Applicant : Randy G. Cooper et al.
Serial No. : 10/730,637
Filed : December 8, 2003
Page : 9 of 13

Attorney Docket No. P-JK-01470-A

REMARKS

FIG. 2A

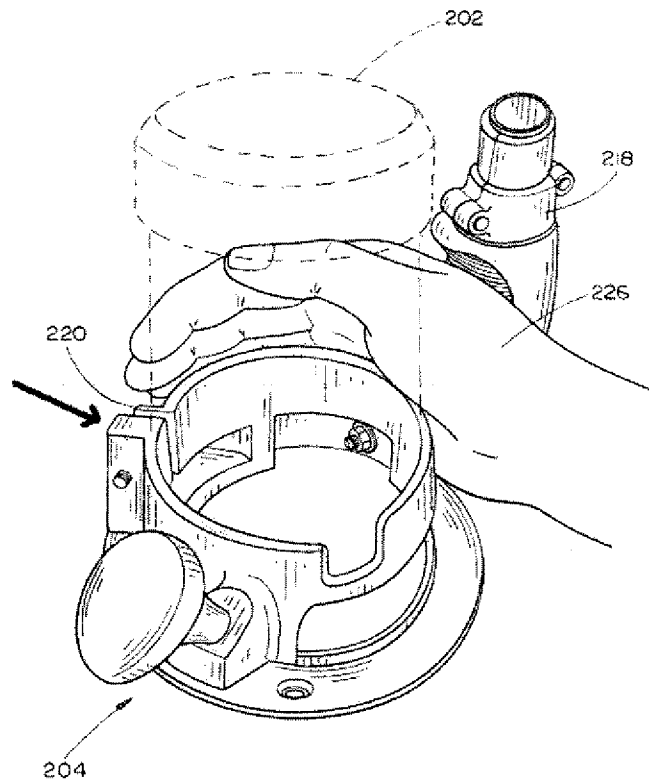
The drawings have been objected to under 37 C.F.R. § 1.83(a) for failure to show the claimed "member configured to clamp the base about the motor housing." However, this element is shown in the drawings, e.g., as indicated by the bold arrow in annotated Fig. 2 below:

Accordingly, withdrawal of this drawing objection is respectfully requested.
